**SUMMIT ORCHARDS NORTH PRELIMINARY DEVELOPMENT PLAN**

1201 & 1151 NW WARD RD.  
LEE'S SUMMIT, MO

**SITE UTILITY PLAN**

**C5**

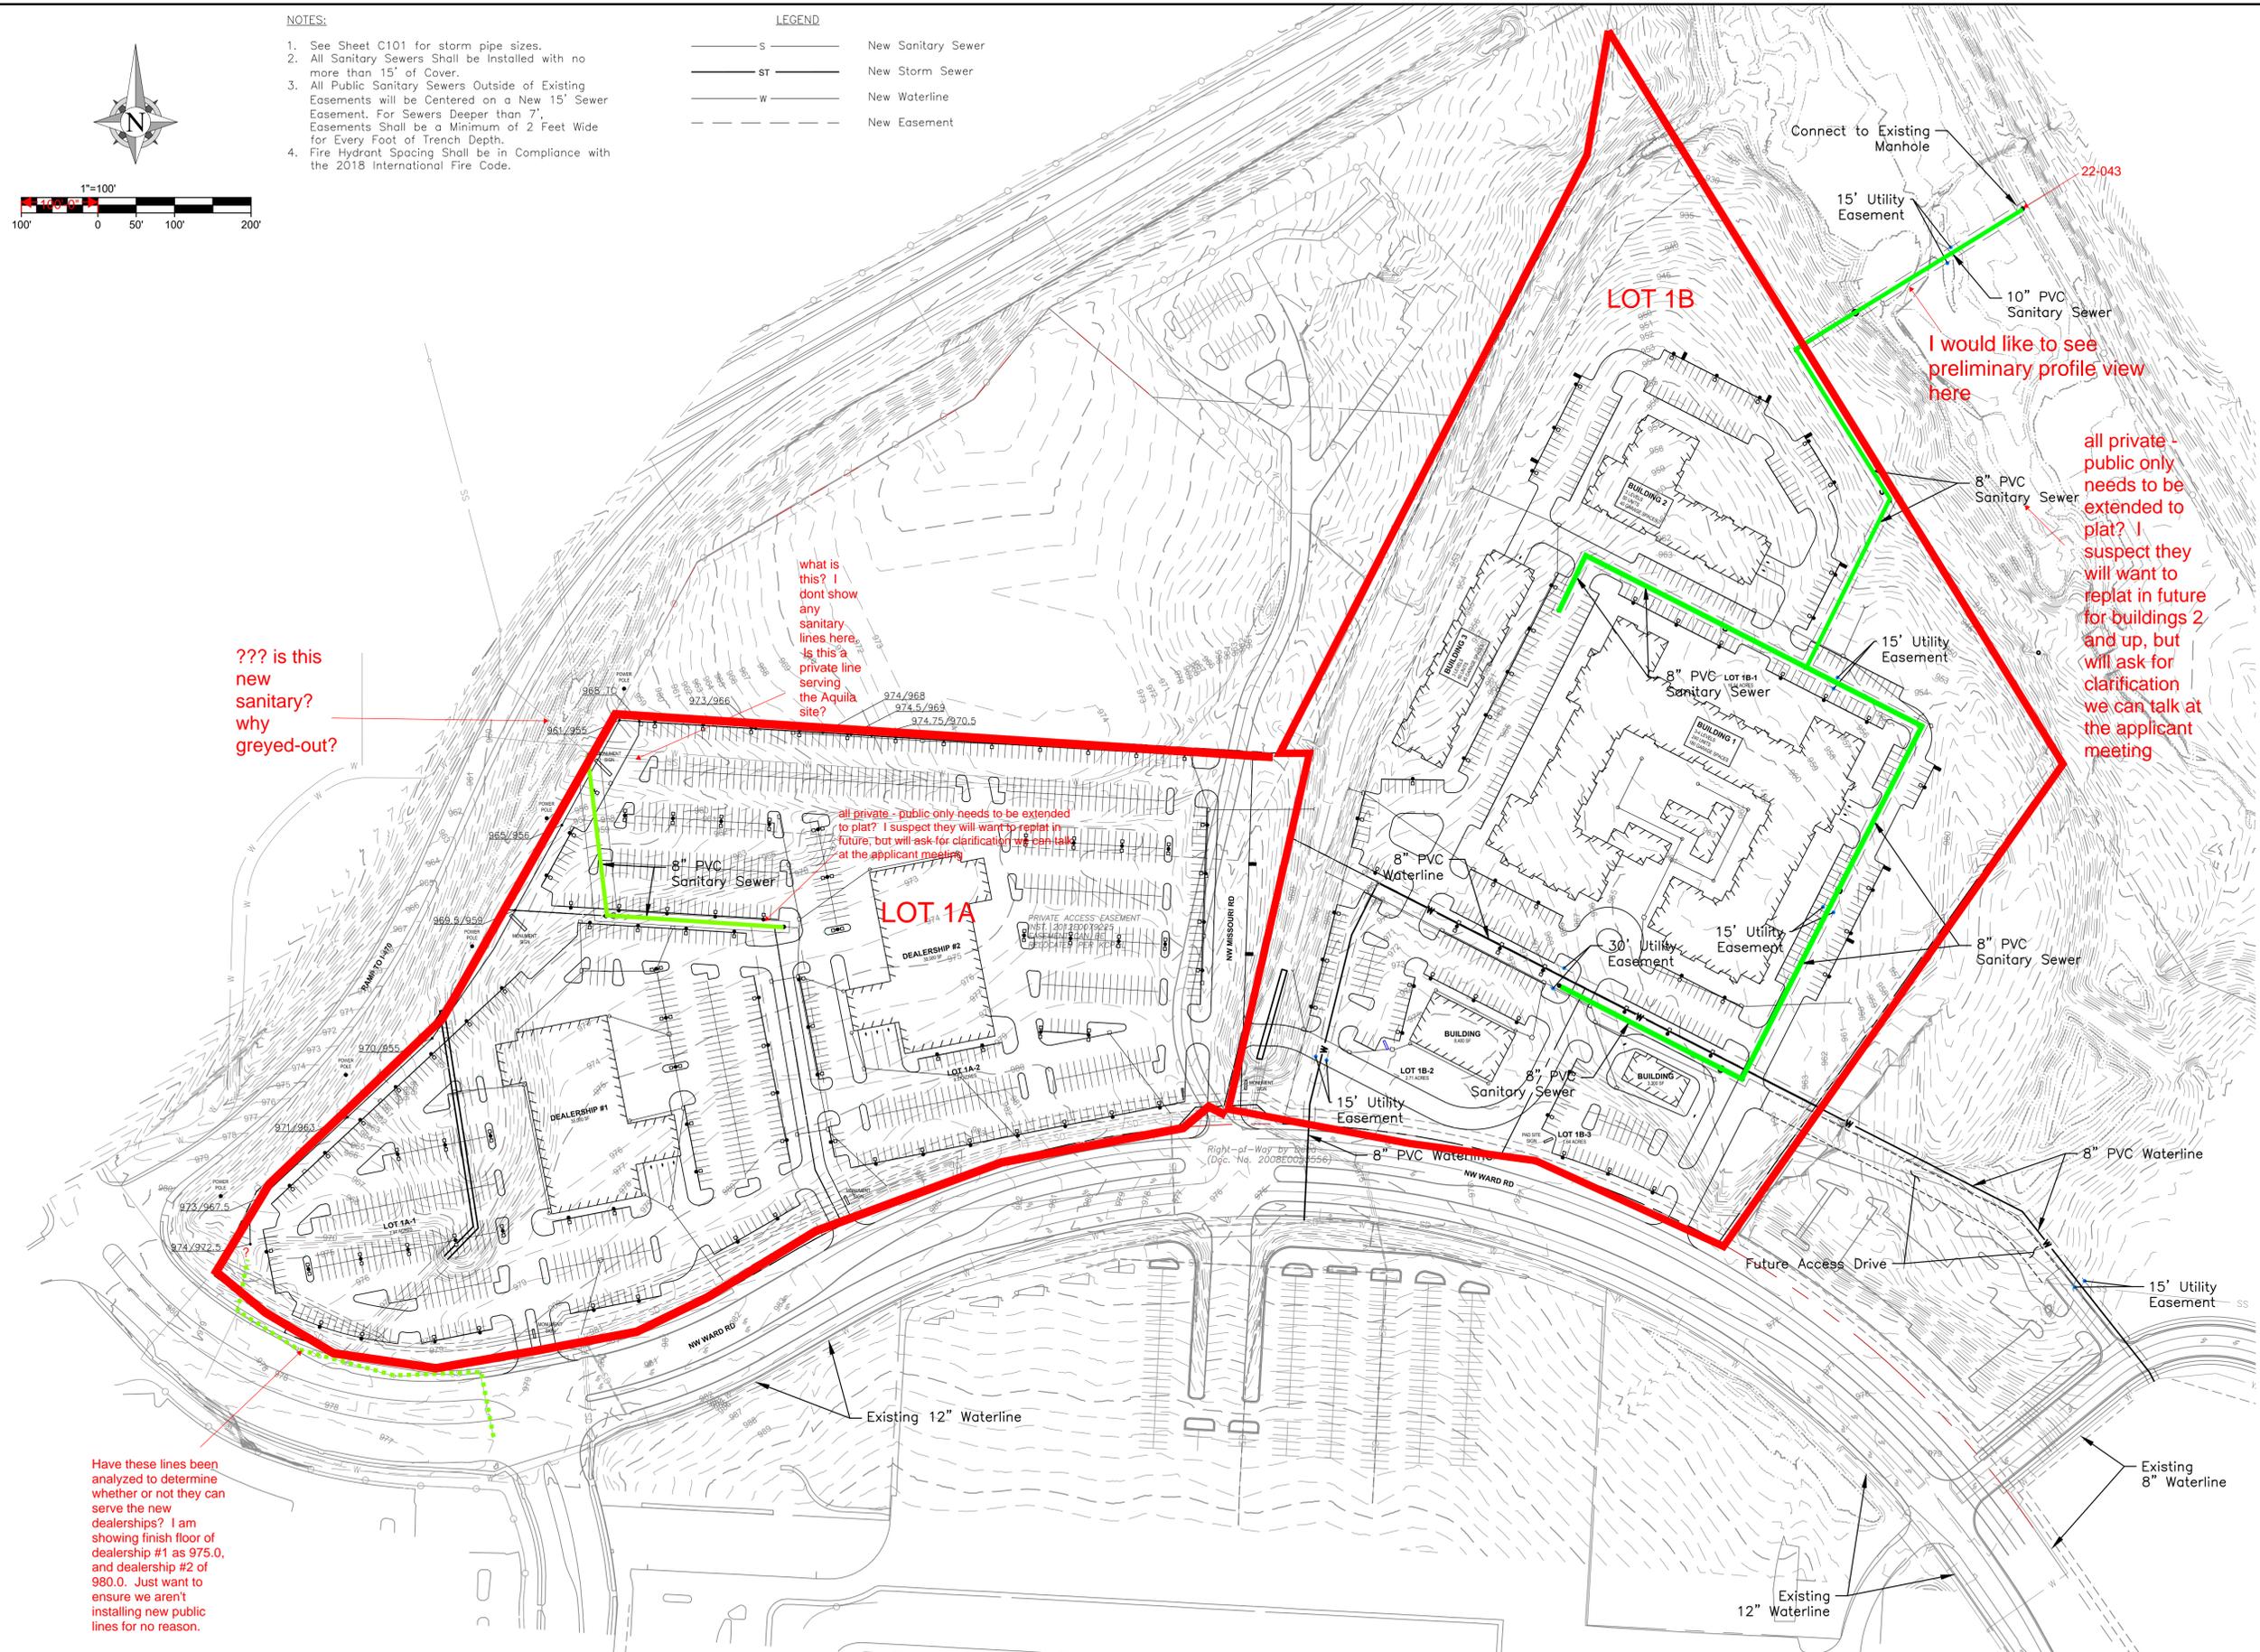
??? is this new sanitary? why greyed-out?

what is this? I dont show any sanitary lines here. Is this a private line serving the Aquila site?

all private - public only needs to be extended to plat? I suspect they will want to replat in future, but will ask for clarification we can talk at the applicant meeting

Have these lines been analyzed to determine whether or not they can serve the new dealerships? I am showing finish floor of dealership #1 as 975.0, and dealership #2 of 980.0. Just want to ensure we arent installing new public lines for no reason.

I would like to see preliminary profile view here

all private - public only needs to be extended to plat? I suspect they will want to replat in future for buildings 2 and up, but will ask for clarification we can talk at the applicant meeting
